# UNITED STATES PATENT AND TRADEMARK OFFICE

APPLICATION NO.	FILING DATE	FIRST NAMED INVENTOR	ATTORNEY DOCKET NO.	CONFIRMATION NO.
10/510,109	05/23/2005	Firmin Garcia	Q83563	5076

<b>Office Action Summary</b>	<b>Application No.</b> 10/510,109	<b>Applicant(s)</b> GARCIA ET AL.	
	<b>Examiner</b> Jason J. Boeckmann	<b>Art Unit</b> 3752

Examiners marked up figure.

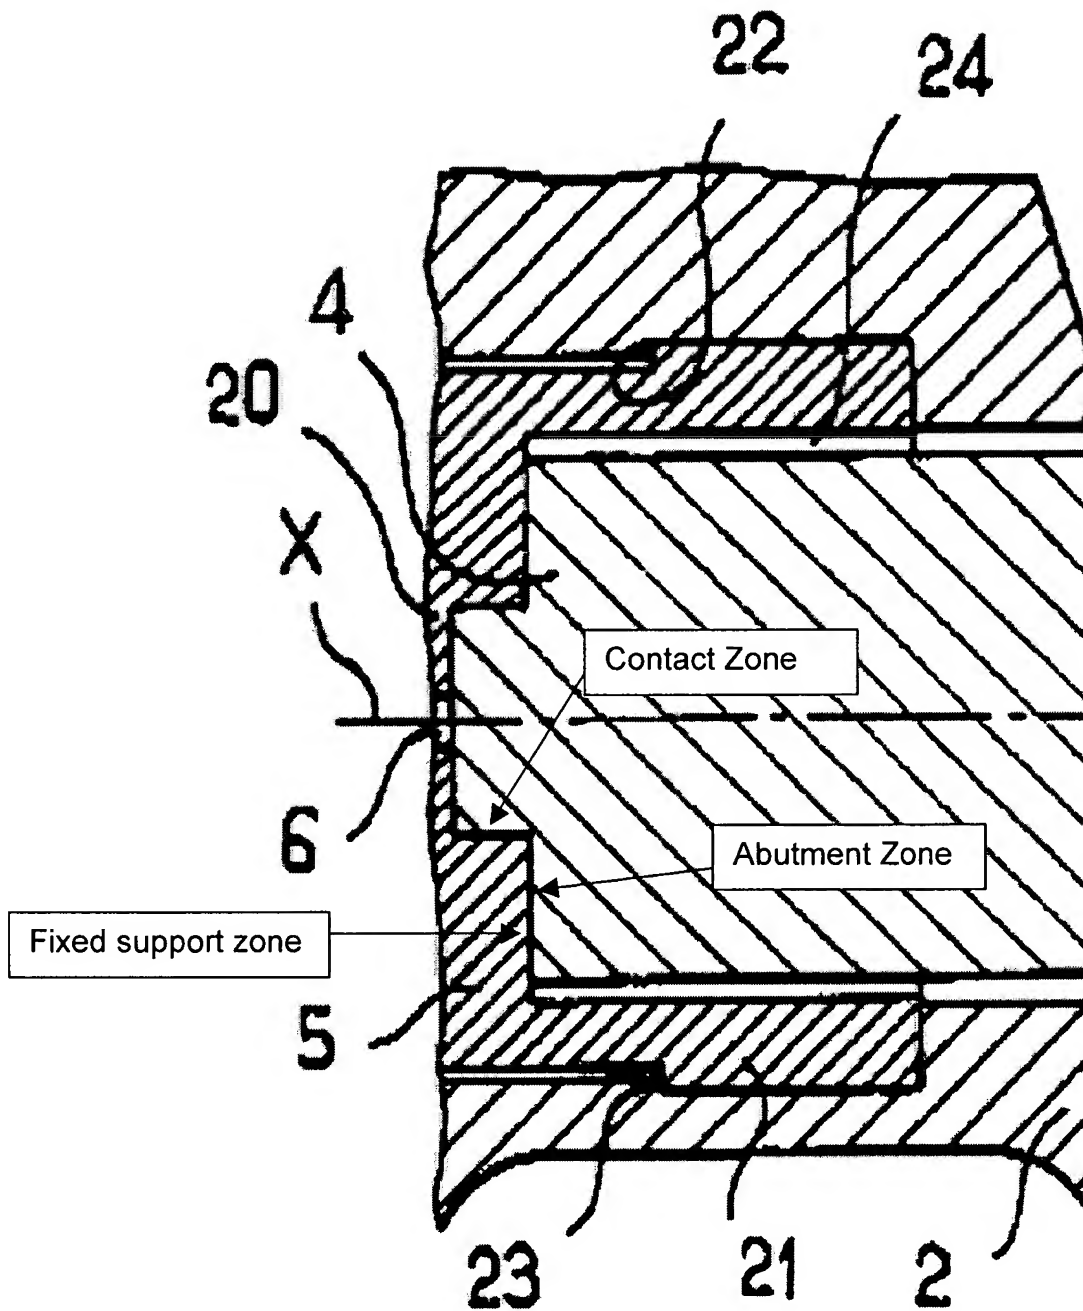
Lacout shows a dispenser head (1) comprising a connection sleeve (T), a dispenser orifice (6), a duct (10) connecting the connection sleeve (T) to the dispenser orifice (6) and a press surface (30). The head further comprising a shutter (4) that is housed at least in part in the duct (10), which is resiliently biased by spring means (13) towards the dispenser orifice (6). The shutter (4) includes a contact zone (located on the shutter, see marked up figure on page 7) that bears in a resilient leak tight manor against the dispensing orifice (6). The shutter being axially movable in such a means as to withdraw its contact zone form the dispensing orifice (6) creating an outlet passageway for the fluid when sufficient pressure is exerted on the press surface (30). The shutter (4) also includes at least one abutment zone (located on the shutter, see

marked up figure on page 7), located remote from the contact zone, that is resiliently biased by the spring means (13) against a fixed support zone (located on the end piece 5, see marked up figure on page 7). Lacout does not disclose that at least one of the dispenser orifice and the contact zone present a frustoconical configuration. However, Clanet et al shows a dispenser head (18) including a shutter (23) and a dispensing orifice (29), the shutter and the dispensing orifice both having frustoconical configurations (figure 4). It would have been obvious to one of ordinary skill in the art at the time of the applicant's invention, under the teachings of Clanet et al, to construct the dispensing orifice (6) and contact surface of Lacout, with a frustoconical configuration in order to create a better seal between them, for when the dispenser head is not in use.

Regarding claims 6 and 15, the dispenser head (1) includes a body (45) and a dispenser end piece (5) connected to the body, the end piece (5) forming the duct (10) and the dispenser orifice (6).
